Mitsubishi hoist

No. 855-0314

Notice of change in auxiliary cable armor for push-button switch

| Push-Button Switch Outline | Auxiliary Cable Armor | |

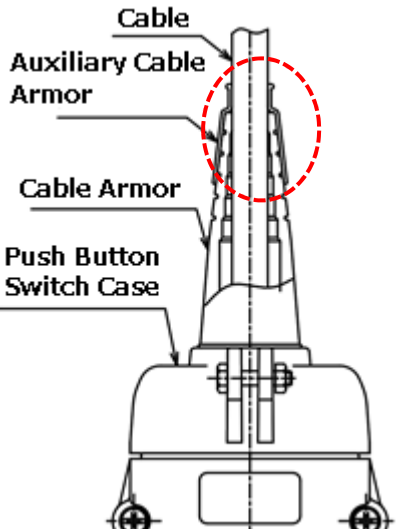
1. Changed content
The shape of auxiliary cable armor for the push-button switch will be changed accordingly.
2. Subject models
All hoist models (Including service parts)
3. Reason for change
Change has been made due to parts manufacturer's convenience.
(Aging of the mold and armor consolidation)
4. Schedule for change
Changes will be made sequentially from the production in August 2019.
5. Changes

| Push-Button Switch Outline | Auxiliary Cable Armor | |
|---|---|--|
|  |  Model: HA type Material: Synthetic rubber Thickness: Approximately 2mm |  Mode: HAI type Material: Silicone rubber Thickness: Approximately 1mm |

The changed auxiliary cable armor has been adopted and used in outdoor specifications.
